MAWSS SUBDIVISION, USA ADDITION TO

APPLICATION NUMBER 6 DATE April 21, 2016

APPLICANT MAWSS Subdivision, USA Addition to

REQUEST Subdivision

DETAIL SITE PLAN

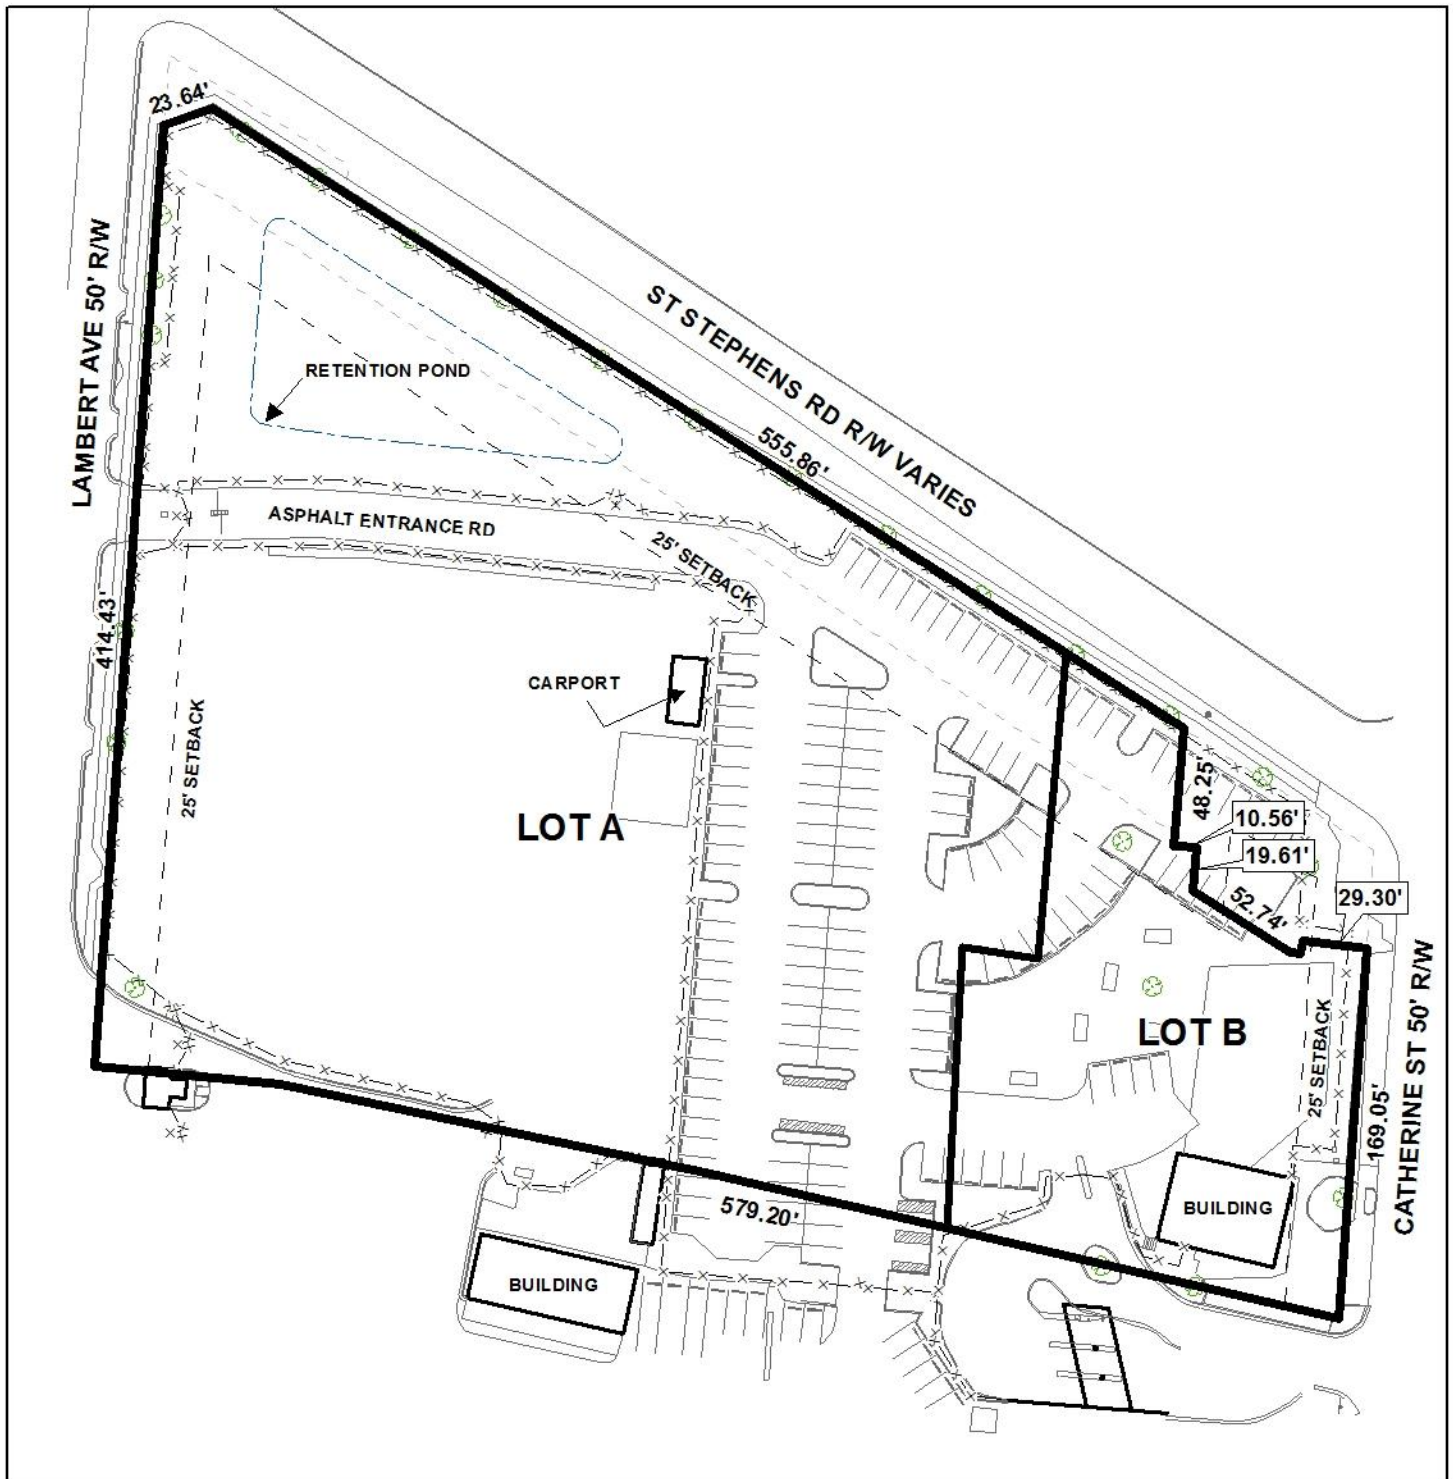
- B. Review and revise the written legal description or written bearing length along the north property line of Parcel 2.
- C. Show and label the MFFE (Minimum Finished Floor Elevation) on each lot that contains an AE, V, or X (shaded) flood zone designation.

- D. Provide and label the monument set or found at each subdivision corner.
- E. Provide the Surveyor's, Owner's (notarized), Planning Commission, and Traffic Engineering signatures.

It should be noted that the interior common property line between the two proposed lots is not clearly indicated on the plat; therefore, the plat should be revised to indicate this line in bold on the Final Plat to match the exterior property lines.

Both lots would meet the minimum size requirements of the Section V.D.2. of the Subdivision Regulations. The lots are labeled with their sizes in square feet and acres on the plat and this should be retained on the Final Plat, adjusted for any required dedication, or a table should be furnished on the Final Plat providing the same information. The site fronts onto St. Stephens Road, North Catherine Street and Lambert Avenue. North Catherine Street and Lambert Avenue are minor streets with compliant 50' rights-of-way; therefore, no dedication would be required along those streets. St Stephens Road is a component of the Major Street Plan in this area with a planned 100' right-of-way. As the previous approval in 1997 only required the placement of the minimum building setback line to reflect the future right-of-way width of St Stephens Road, the same requirement should be placed on the application at hand. Therefore, no dedication should be required along St. Stephens Road. However, a 25' corner radius should be dedicated at the intersection of St. Stephens Road and Lambert Avenue.

The 25' minimum building setback line is indicated on the plat and should be retained on the Final Plat, adjusted for the future right-of-way line along St. Stephens Road.

- 1) revision of the plat to indicate the common internal property line between the two lots in bold to match the exterior property lines;
- 2) labeling of each lot with its size in square feet and acres after any required dedication, or the furnishing of a table on the Final Plat providing the same information;
- 3) revision of the plat to indicate the 25' minimum building setback line along St. Stephens Road as measured from the future right-of-way width of 100';

- 4) dedication to provide a 25' corner radius at the intersection of St. Stephens Road and Lambert Avenue;
- 5) retention of the 25' minimum building setback line along Catherine Street and Lambert Avenue;

- 6) adjustment of the 25' minimum building setback line along St. Stephens Road so as to be measured from the future right-of-way line;
- 7) subject to the Engineering comments: *[The following comments should be addressed prior to submitting the FINAL PLAT for acceptance and signature by the City Engineer: A. Provide all of the required information on the SUBDIVISION PLAT (i.e. signature blocks, signatures, certification statements, written legal description, required notes, legend, scale, bearings and distances) that is required by the current Alabama State Board of Licensure for Professional Engineers and Land Surveyors. B. Review and revise the written legal description or written bearing length along the north property line of Parcel 2. C. Show and label the MFFE (Minimum Finished Floor Elevation) on each lot that contains an AE, V, or X (shaded) flood zone designation. D. Provide and label the monument set or found at each subdivision corner. E. Provide the Surveyor's, Owner's (notarized), Planning Commission, and Traffic Engineering signatures. F. Add a note to the SUBDIVISION PLAT stating that a Land Disturbance permit will be required for any land disturbing activity in accordance with Mobile City Code, Chapter 17, Storm Water Management and Flood Control); the City of Mobile, Alabama Flood Plain Management Plan (1984); and, the Rules For Erosion and Sedimentation Control and Storm Water Runoff Control. G. Add a note to the Plat stating that the approval of all applicable federal, state, and local agencies (including all storm water runoff, wetland and floodplain requirements) will be required prior to the issuance of a Land Disturbance permit. H. Add a note that sidewalk is required to be constructed, and/or repaired, along the frontage of each lot, or parcel, at time of new development or construction, unless a sidewalk waiver is approved. I. Provide a copy of the FINAL PLAT to the Engineering Dept. for review prior to obtaining any signatures. J. Provide a copy of the Final Plat along with the original when submitting for City Engineer signature.];*
